**Ombygging fra 300 til 320 mm**

**LuK Part Nr. 130 0005 10 - 320mm DGVM**

**JOHN DEERE - 2130, 2640, 3030, 3120, 3130**

**INFO:** 130 0005 10 replaces / ersetzt / remplace / sustituye a / sostituisce 130 0005 20

**FLYWHEEL  
SVINGHJUL**

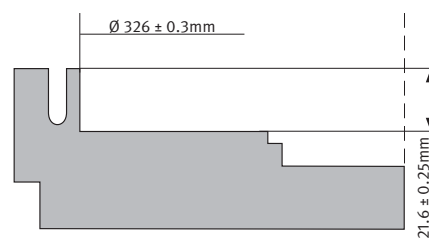
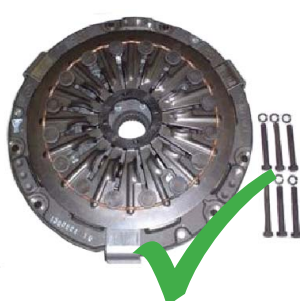
Please ensure that the flywheel is machined to a diameter of  $\varnothing 326 \pm 0.3\text{mm}$  and to a pot depth of  $21.6 \pm 0.25\text{mm}$ . The clutch should be fitted with 6 x  $\frac{3}{8}$ " UNC x  $2\frac{3}{4}$ " bolts.

Pass på at svinghjulet er maskinert til diameter  $\varnothing 326 \pm 0.3\text{mm}$  og til en dybde på  $21,6 \pm 0,25\text{mm}$ . Clutchen skal festes med 6 x  $\frac{3}{8}$  "UNC x  $2\frac{3}{4}$ " bolter.
